Botley West Solar Farm (Ref: EN010147)

The Examining Authority's First Written Questions and Requests for Information (ExQ1)

Joint response from the Host Authorities

**Host Authority Response to the Examining Authority's First Written Questions and Requests for Information (ExQ1
Tuesday 1 July 2025**

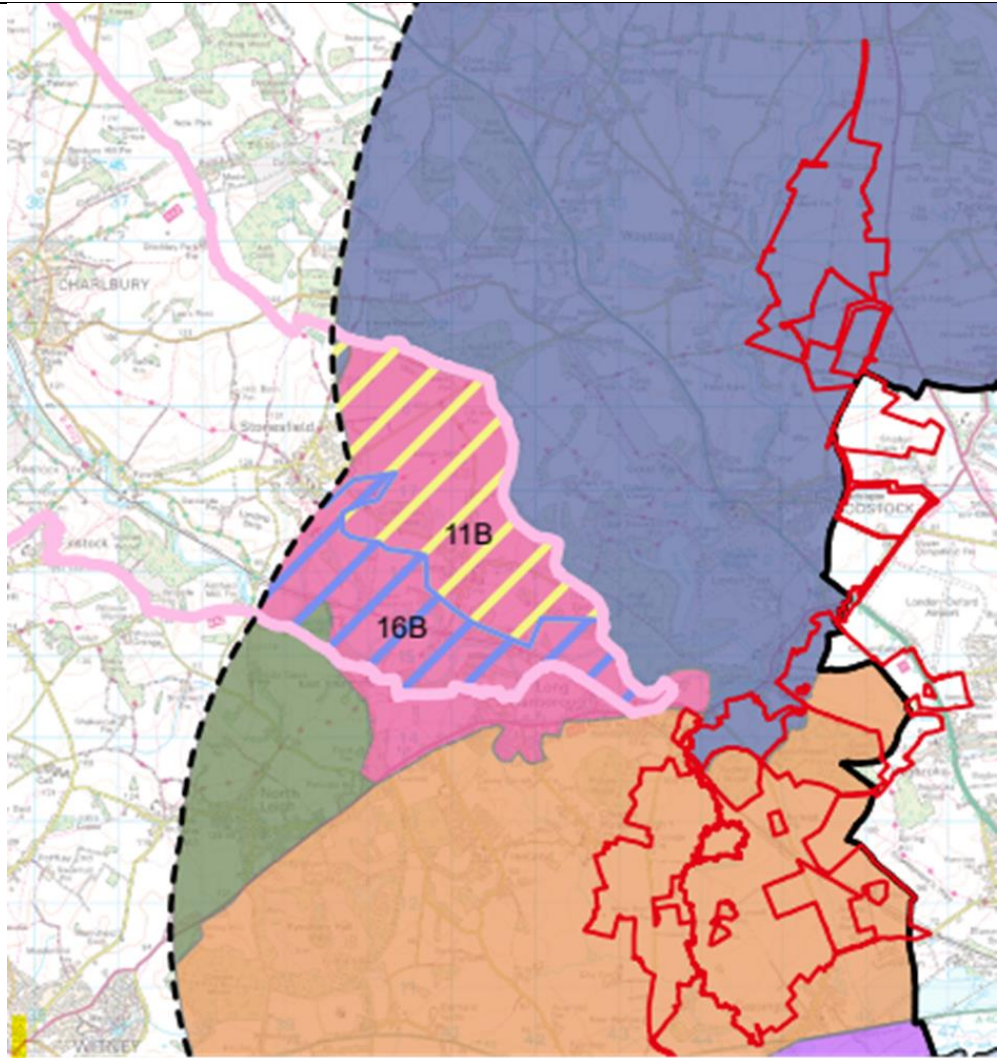
<p>Planning application P24/V2489/FUL, Land to the west of Red House Farm, is adjacent to the southern site and remains under consideration. The application was submitted in December 2024, after the DCO application, and is a resubmission of withdrawn application P23/V2624/FUL (listed as a tier 2 project [APP-224]). A plan showing the location is included in the Cumnor Parish Council Written Representation [REP1-056].</p> <p>WODC:</p> <p>There is one additional planning application, for a site adjacent to the central part of the Project Area - This would be categorised as a Tier 1 scheme, for a submitted application but not yet determined.</p> <p>24/03069/FUL - Goose Eye Farm Eynsham Witney Oxfordshire OX29 4EH (Pending Consideration) Application is adjacent to project area</p> <p>- Construction of a single dwelling house with ancillary buildings comprising pavilion, garage and plant room, workshop and wildlife tower in lieu of the existing farmhouse and buildings together with associated landscape works to include lake extension, siting of solar array and tennis court. Provision of new vehicular access.</p> <p>OCC:</p> <p>There are no additional county planning applications that are significant enough to require consideration cumulatively with the Proposed Development.</p>

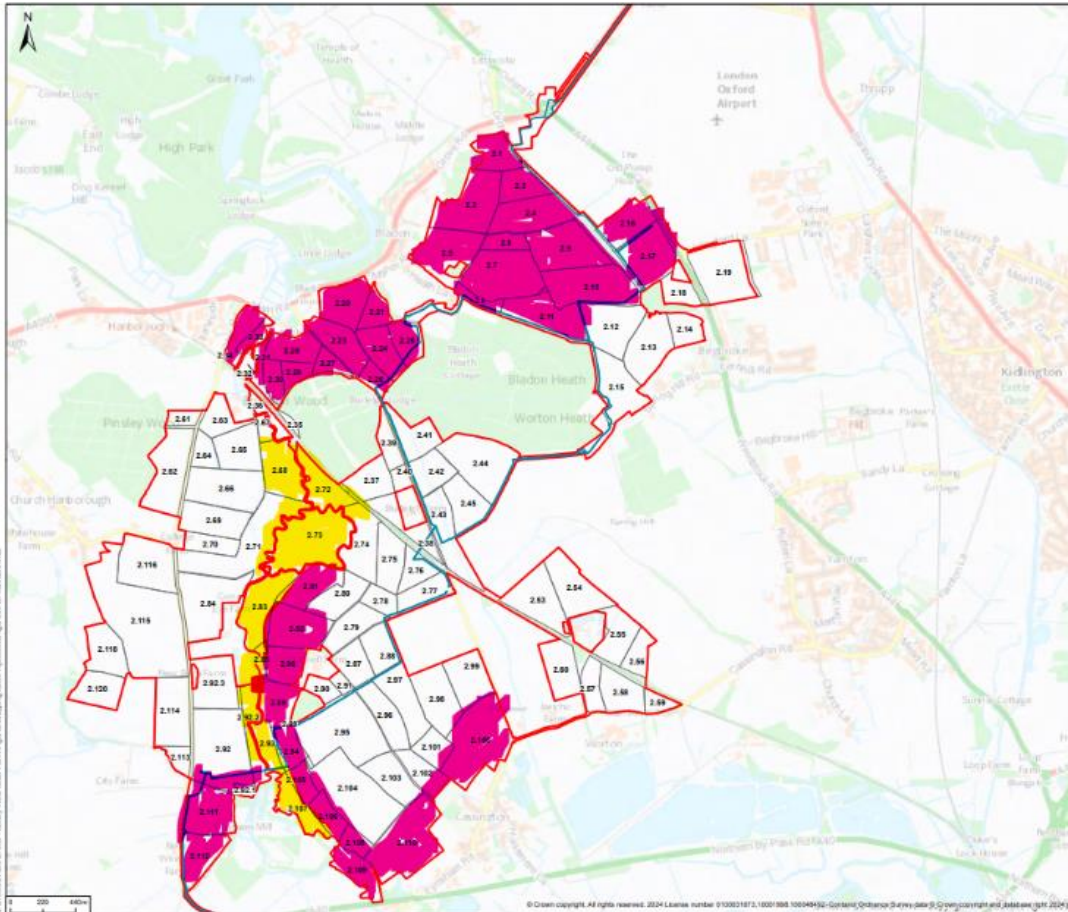
1.6.11	ICOMOS	<p>Extent of proposed omissions</p> <p>Your DL1 submission proposes areas of panels that should be removed from the proposed development in order to be less harmful to the landscape. However, the landscape in question</p>

<p>has no statutory designation and does not form part of a formal buffer to the World Heritage Site (WHS).</p> <p>You state in paragraph 1 of section B of your submission that <i>“ICOMOS-UK has an interest in sustaining the quality of the rural landscape in the UK, which in this instance contributes to the setting of the WHS”</i>.</p> <p>Explain how the areas of panels that you have identified in your submission contribute to the setting of the WHS and how the proposed development within these areas may be harmful to the setting.</p>
